# Value Engineering Study Report

**Project – STP -7063 (1)  
Columbia County**

***Old Petersburg Road  
And Old Evans Road Widening***

RE: Submittal of the Final Value Engineering Report  
Old Petersburg Road and Old Evans Road Widening  
Project Task Order No. 2, Contract TOOESV06796  
**Project No. STP-7063(1), P.I. 250470**  
**Columbia County**

EXISTING TYPICAL SECTION WITH 4'-0" BIKE LANES AND 12'-0" SHOULDERS

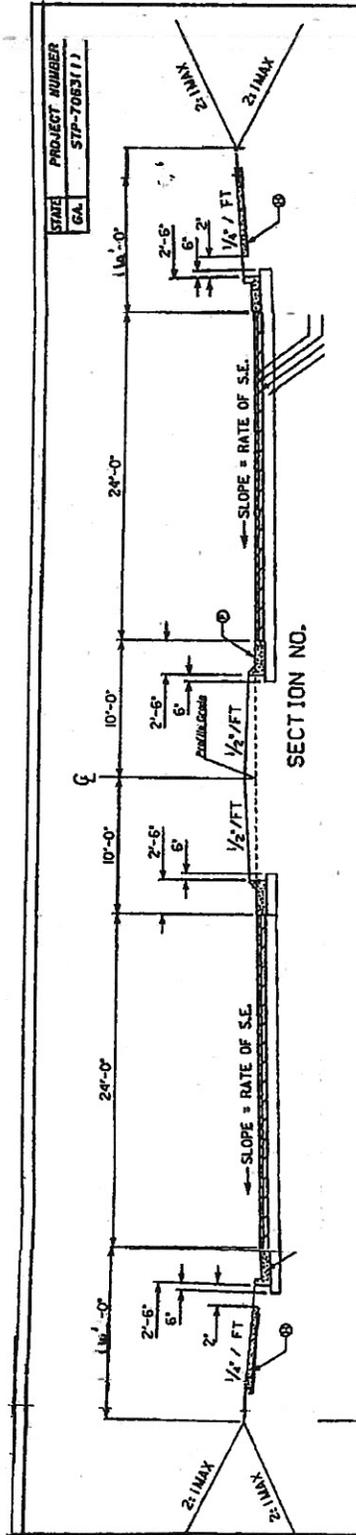
- The original design typical section provides for a 4'-0" Bike Lane in each direction of travel from Station 100+00 to Station 246+00. Also, provides for a 12'-0" shoulder and a 5' 0" sidewalk.

- The alternative design would be a typical section which would provide for deletion of the 4' 0" Bike Lanes from the pavement area. The 4'-0" Bike Trail width would be added to the 12'-0" shoulder and sidewalk area. The 5'-0" sidewalk would be "deleted" for a new total width of 16'. Of this 16'-0", 8'0" would be paved and used as a **Multi-Use Trail**.

PLAN VIEW FOR RETAINING WALL @ STA 98+60 - STA 99+05

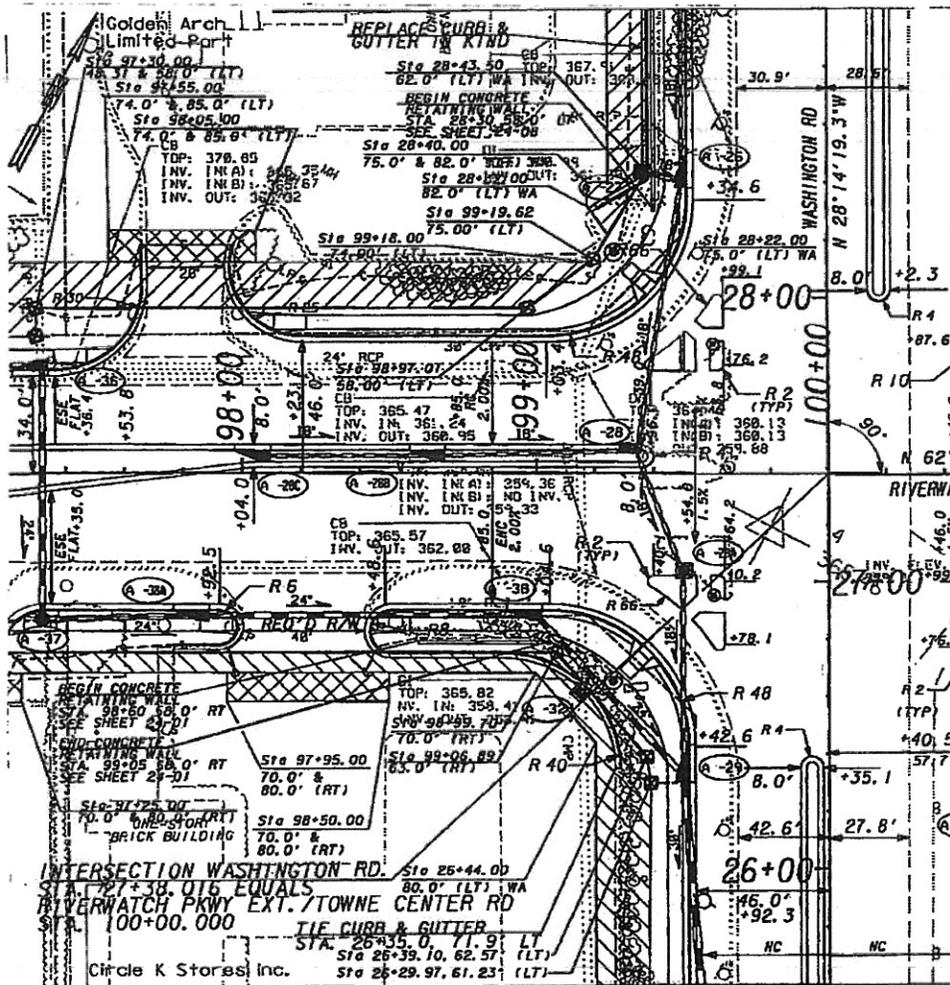
- Construction of Ga. Std 9031L retaining wall at Station 98+60 to Station 99+05, Riverwatch Parkway Extension

- Elimination of Wall and Grade Area from back of sidewalk to back of curb and gutter installed in circle K parking lot. All work would be completed in proposed R/W

PROPOSED CROSS SECTIONS AFTER ELIMINATION  
OF RETAINING WALL @ STA 98+60 - STA 99+05

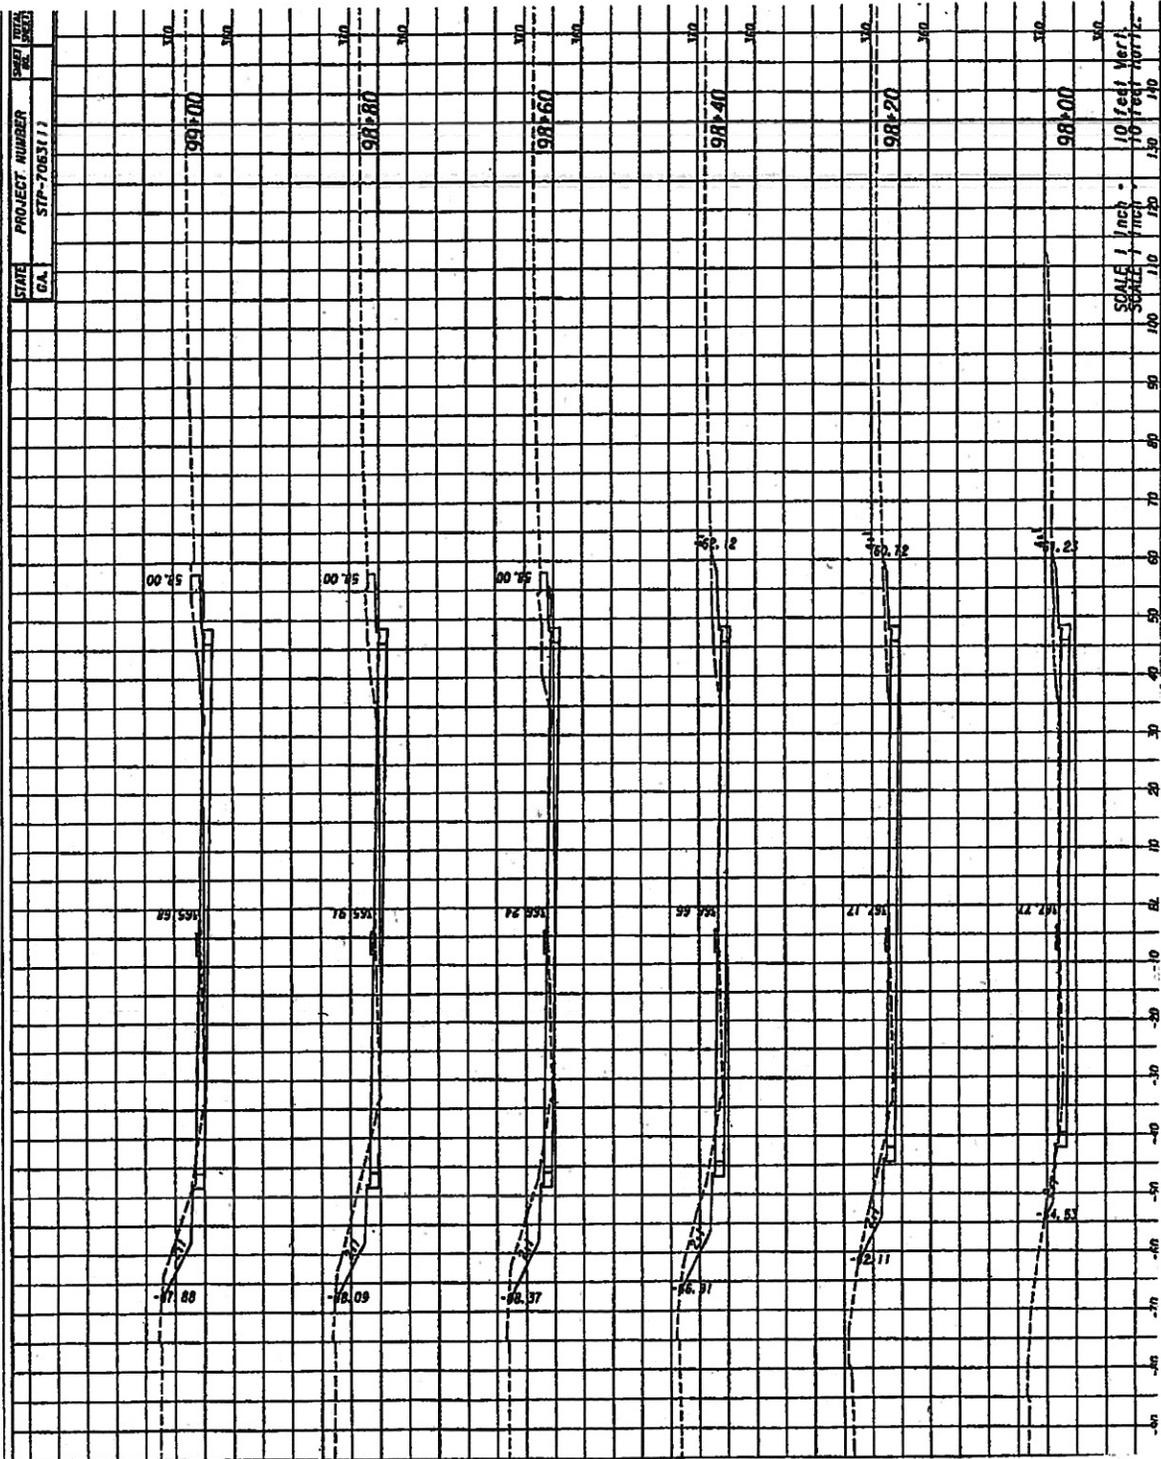
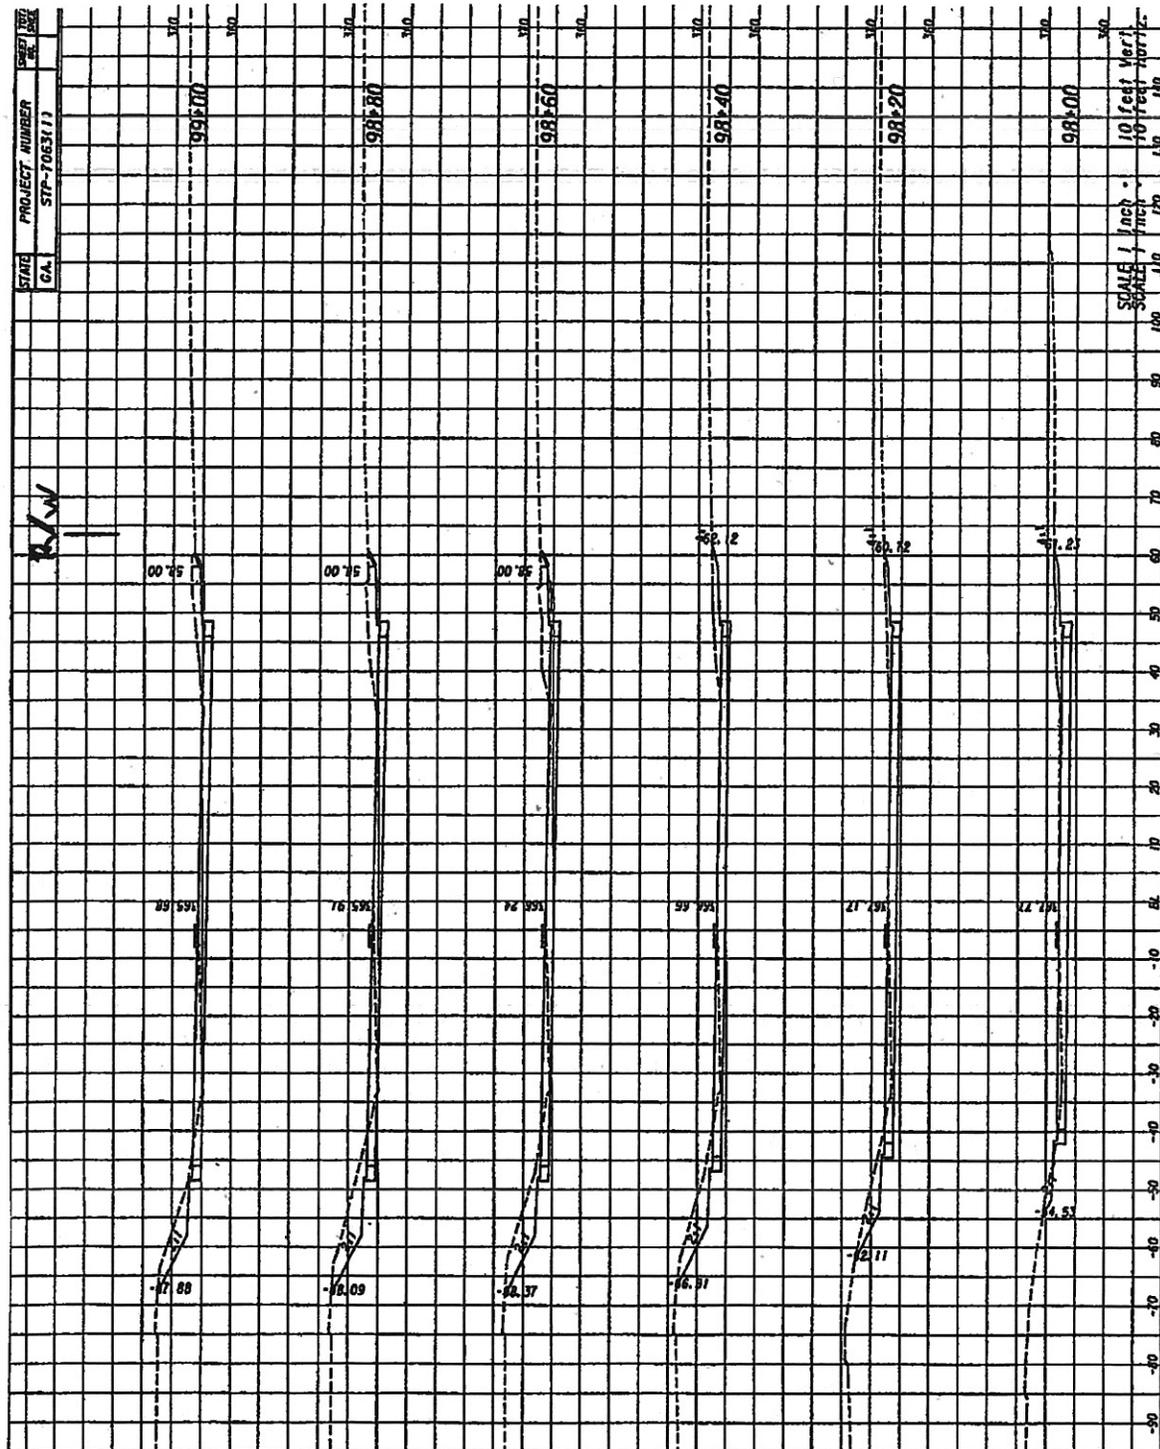
The alternative should simply construction and help avoid utility problems.

TYPICAL SECTION INCLUDING SIDEWALKS

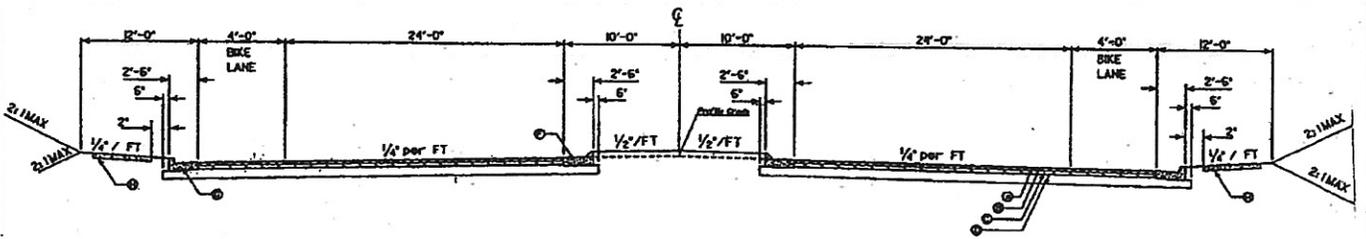
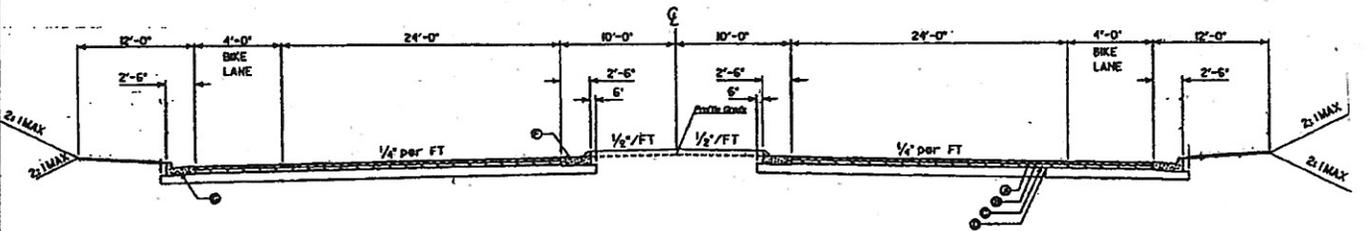
- The alternative proposes to delete sidewalks on minor side streets. These sidewalks do not tie-in to any existing sidewalks and terminate at construction end.

The calculation sheet details the candidates for deletion – should be balanced in view of local requirements imposed on developers – i.e., to provide sidewalks approaching schools, etc.
